**REQUEST FOR PROPOSAL (RFP)**  
**Langley AFB Multiple Award Construction Contract (MACC)**  
**AMENDMENT 04**

**PROJECT NUMBER: MUHJ 08-0008**

**PROJECT TITLE: Repair King Street and Tabb Creek Bridges & Temporarily Relocate Tabb Creek Bridge Utilities, Facilities 404 & 1045**

**Subject RFP is amended as follows: Request Submission of Revised 35% Design Proposals; Incorporate Questions and Answers; Incorporate Communication Run Drawings.**

Attached separately are two pictures depicting the communication runs from F. 1025 to MH 121-9.

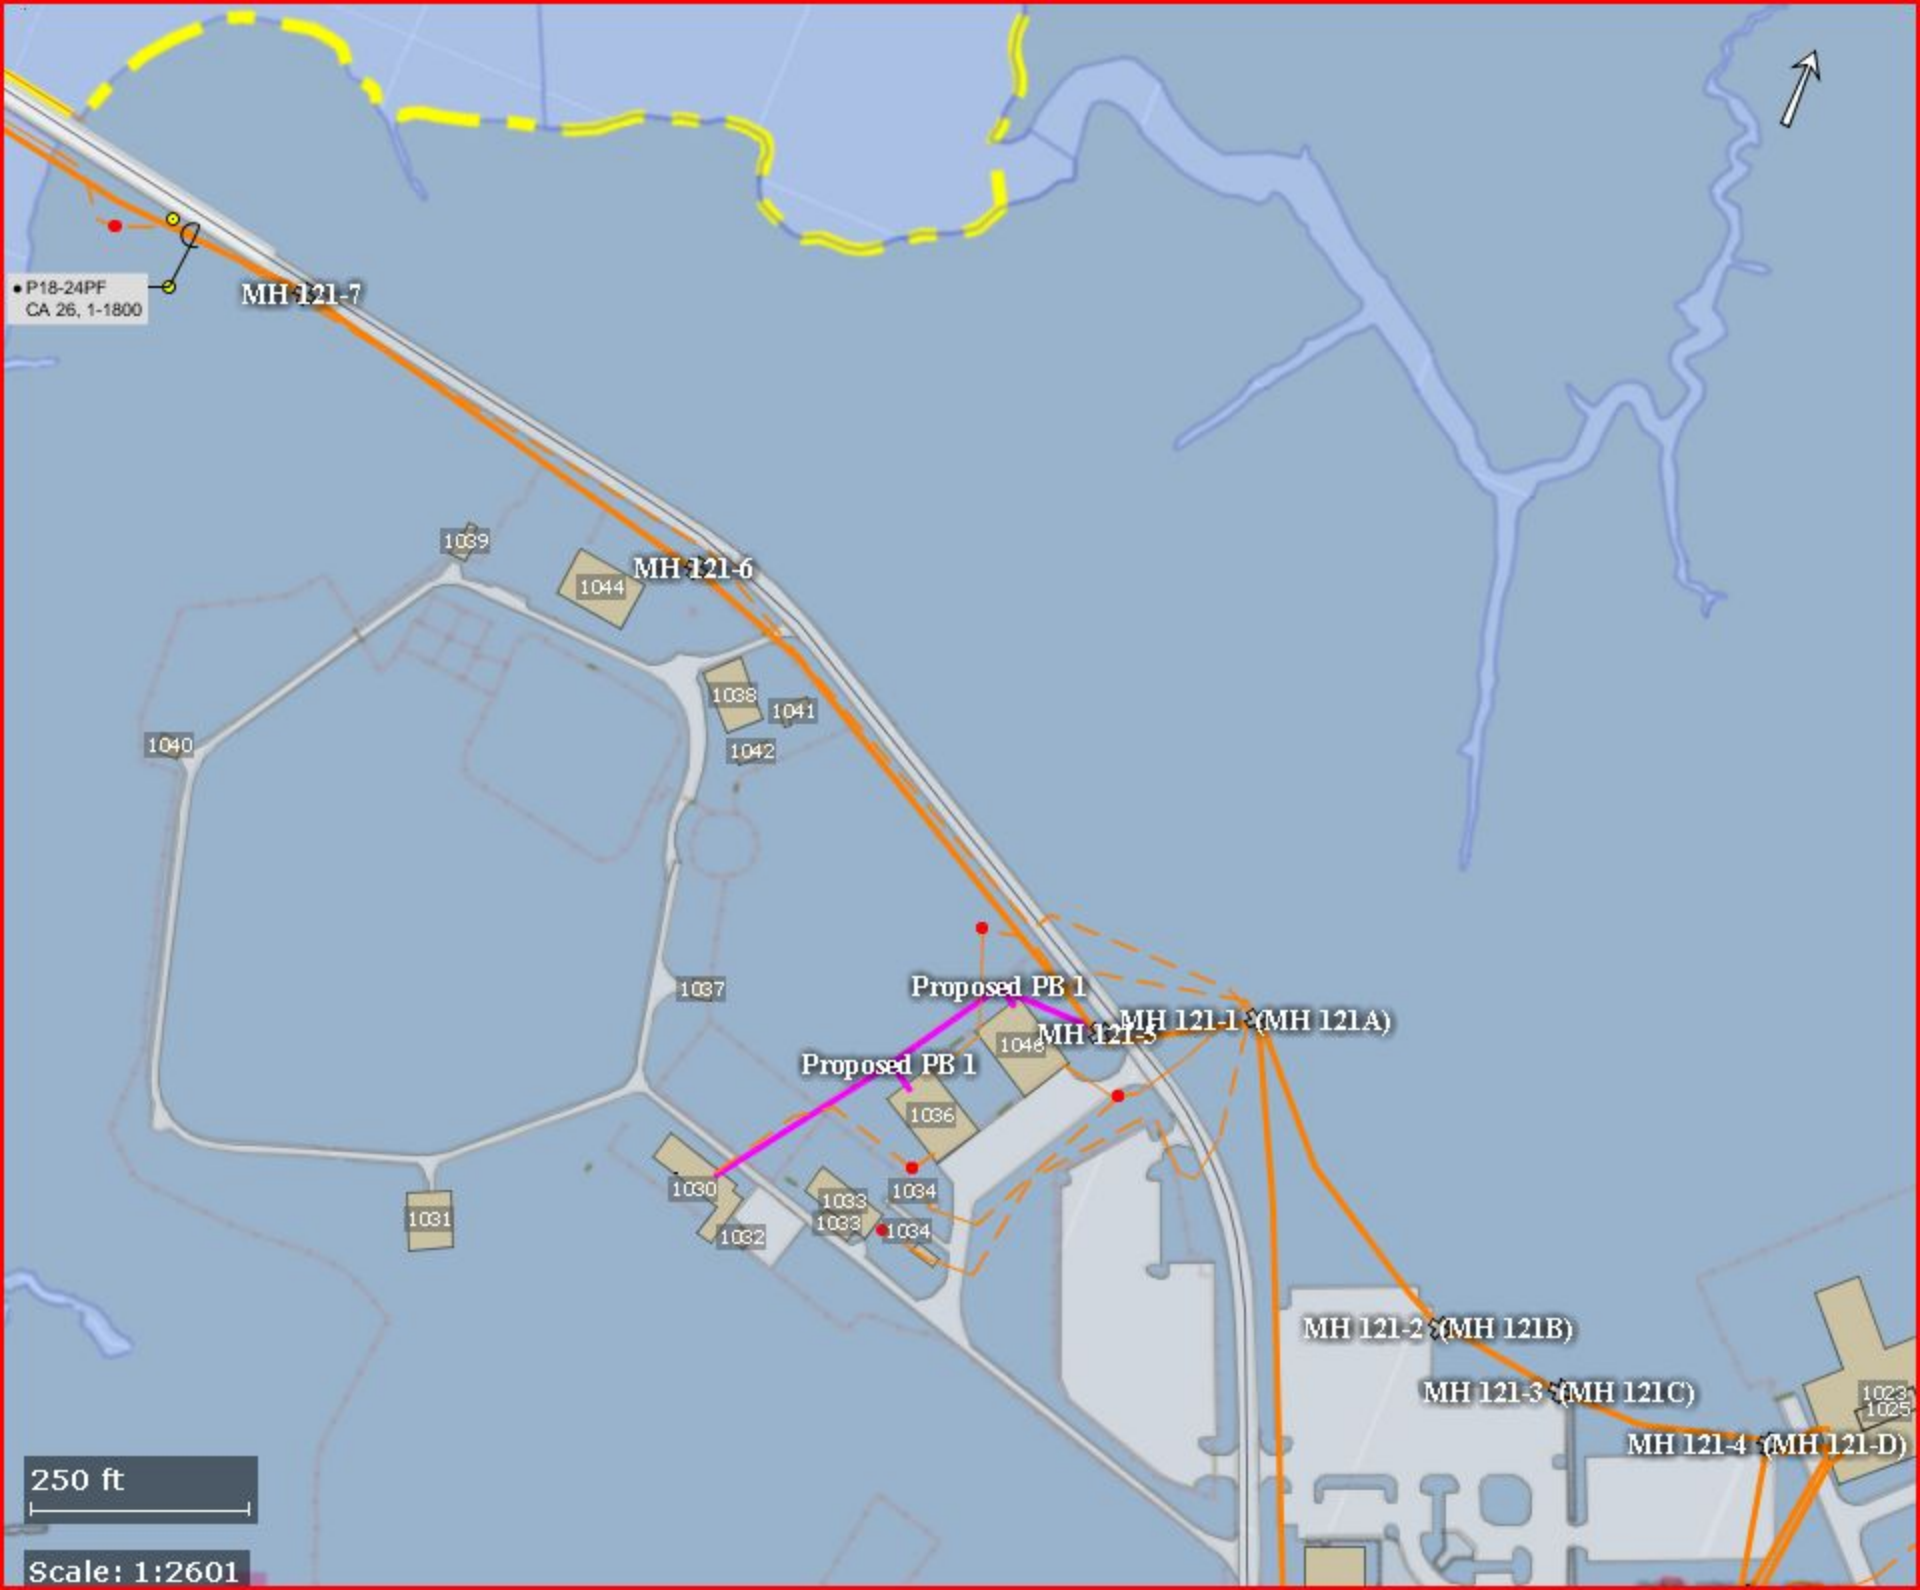
15. The following is provided in response to the question concerning the encasement of Tabb Creek Bridge utilities in concrete duct bank:

*Response:* Electrical - Both sides are encased in concrete to the bridge footers, then PVC across bridge. Communications – Not encased in concrete duct bank.
